No.: 06 TS – 27
December 11, 2006

SUBJECT: **MBE 900 High Tech Grid Heater Installation (EPA04)**

Figure 2 – Grid Heater Installation

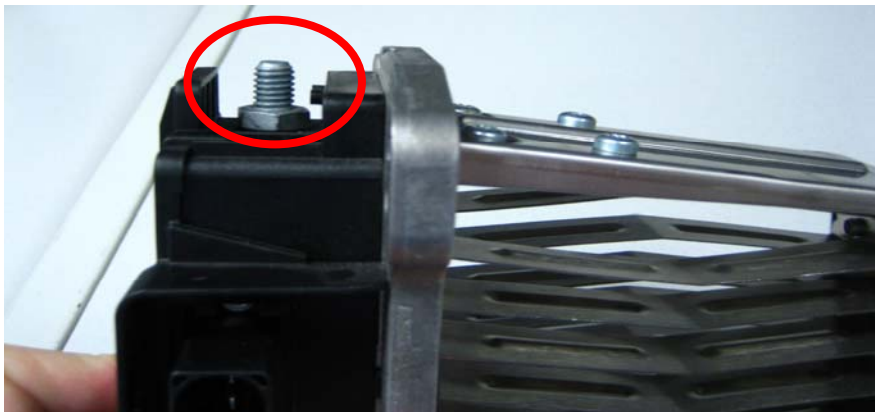
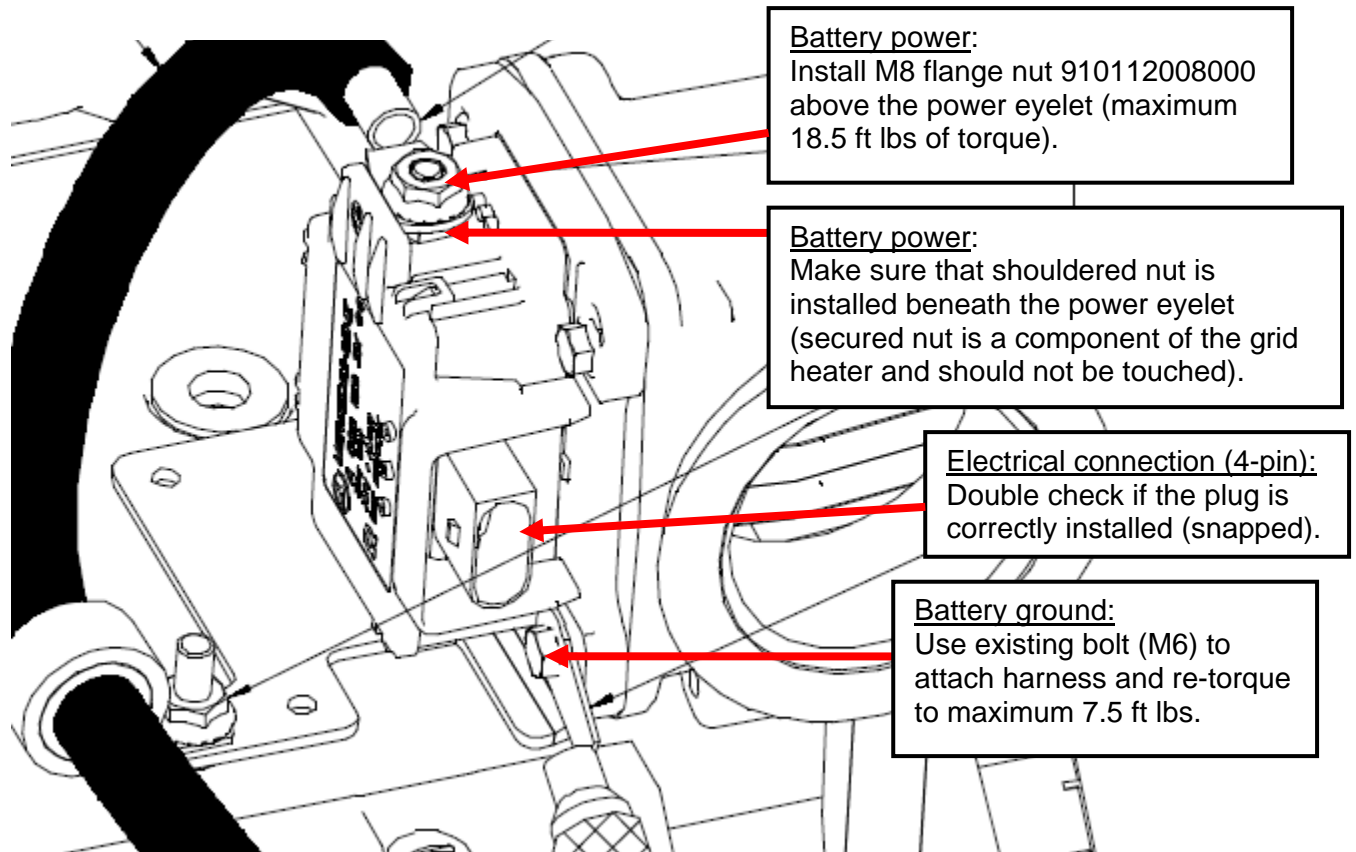
Correct grid heater installation requires the following:

- On the battery power stud, a shouldered nut should remain seated on the housing.
- The battery power eyelet should be mounted on top of the shouldered nut and nut 910112008000 should be added to secure the power eyelet to the device.

Figure 3 - Correct Installation of Power and Ground Studs

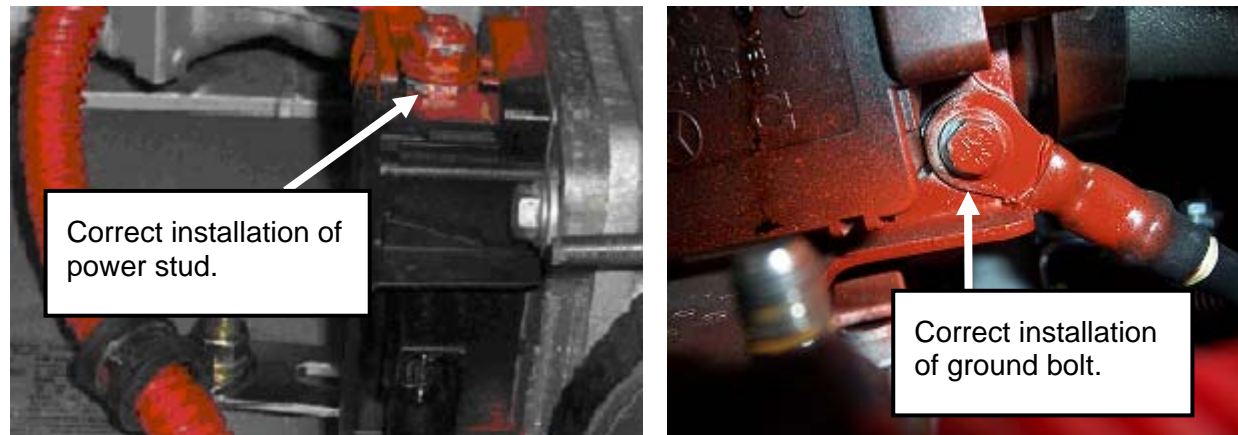
The added top nut on the battery power stud should not be tightened past 18.5 ft lbs of torque, and the M6 bolt on battery ground should not be tightened past 7.5 ft lbs of torque.
